17VARIANCE1080

Future Car Sales Shed

**Louisville Metro Board of Zoning Adjustment
Public Hearing**

**Dante St. Germain, Planner I
December 4, 2017**

Site Photos-Subject Property

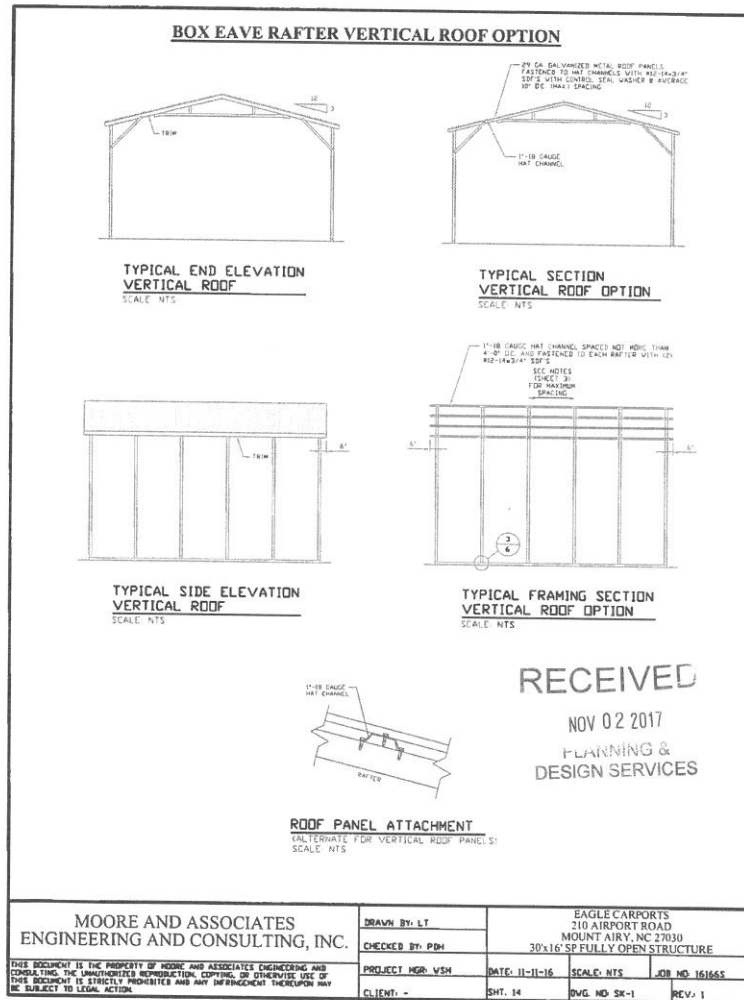
The location of the proposed shed inside the fence.
